Job:
RESIDENTIAL FLAT
BUILDING: - 1147, 1149
PACIFIC HWY & 2 BOBBIN
HEAD ROAD PYMBLE

BASEMENT LEVEL 1

SK04A

PROPOSED SHADOW DIAGRAM - 3PM JUNE 22ND
SCALE 1:200 @ A0

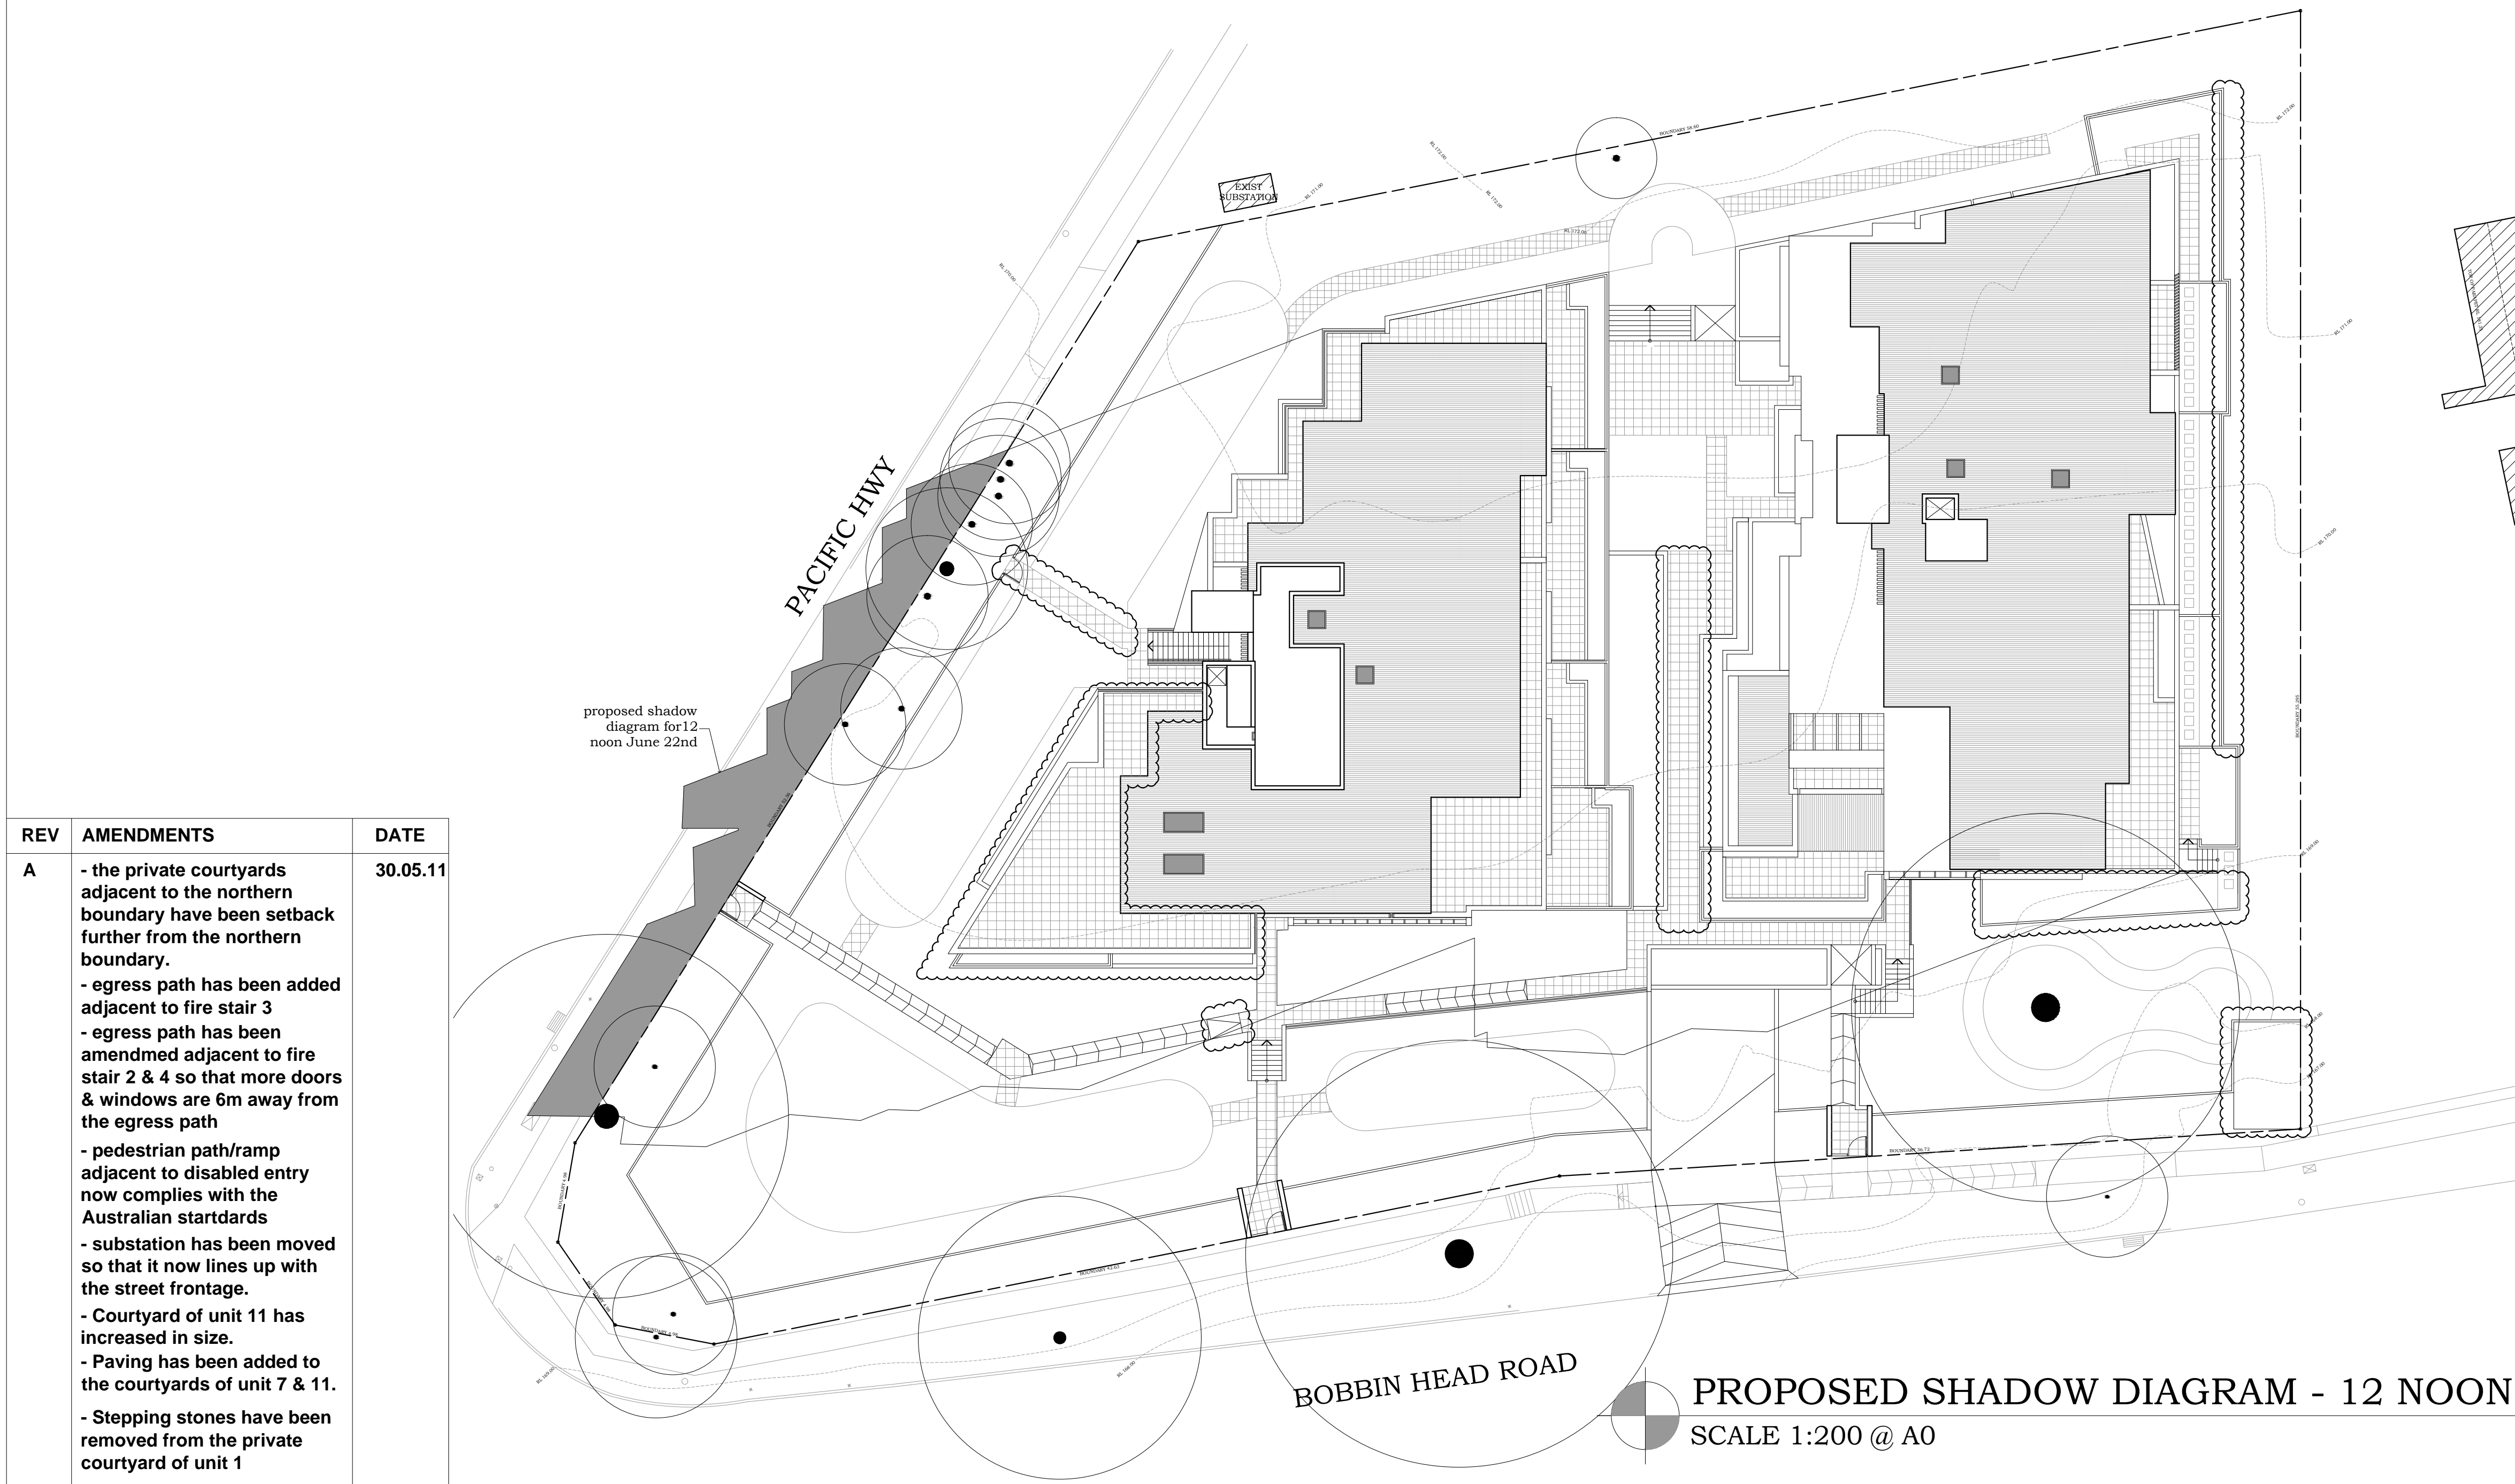
REV	AMENDMENTS	DATE
A	<ul style="list-style-type: none">- the private courtyards adjacent to the northern boundary have been setback further from the northern boundary.- egress path has been added adjacent to fire stair 3- egress path has been amended adjacent to fire stair 2 & 4 so that more doors & windows are 6m away from the egress path- pedestrian path/ramp adjacent to disabled entry now complies with the Australian startdards- substation has been moved so that it now lines up with the street frontage.- Courtyard of unit 11 has increased in size.- Paving has been added to the courtyards of unit 7 & 11.- Stepping stones have been removed from the private courtyard of unit 1	30.05.11

SETBACK ZONE AREA CALCULATION DIAGRAM
SCALE 1:100 @ A0

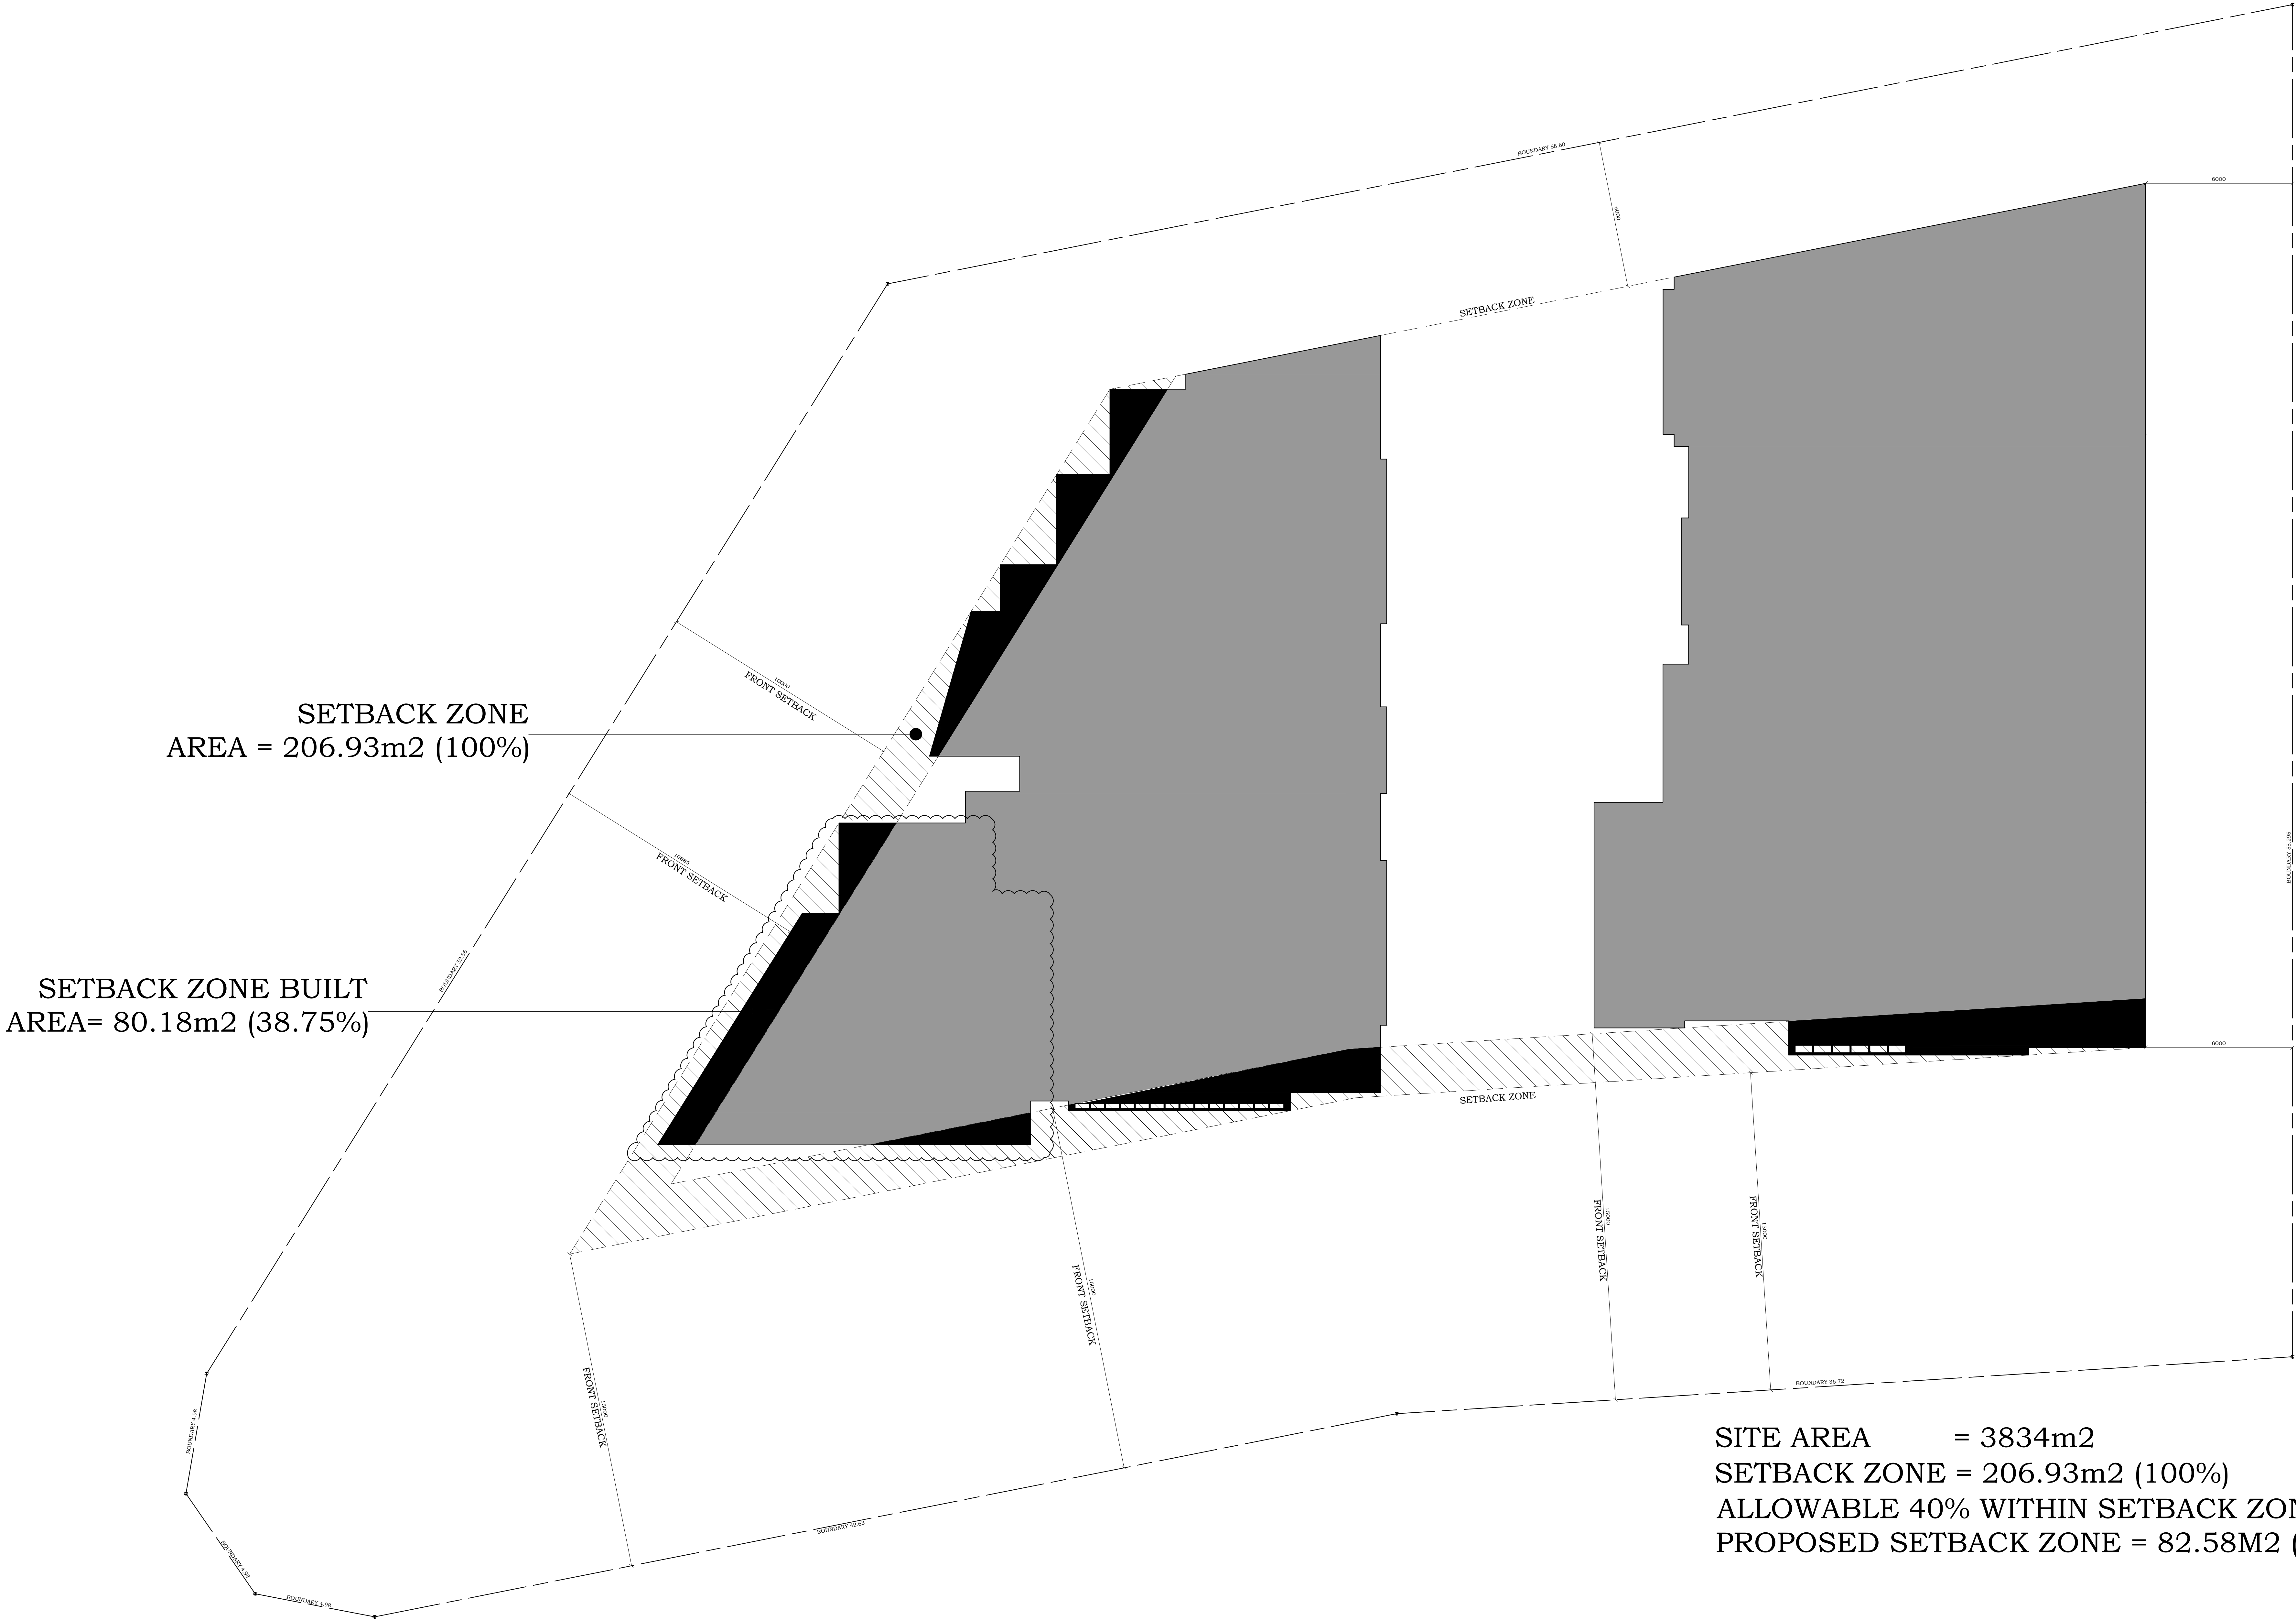
REV	AMENDMENTS	DATE
A	- Setback zone calculation has been updated to reflect changes to the south eastern corner of building	30.05.11
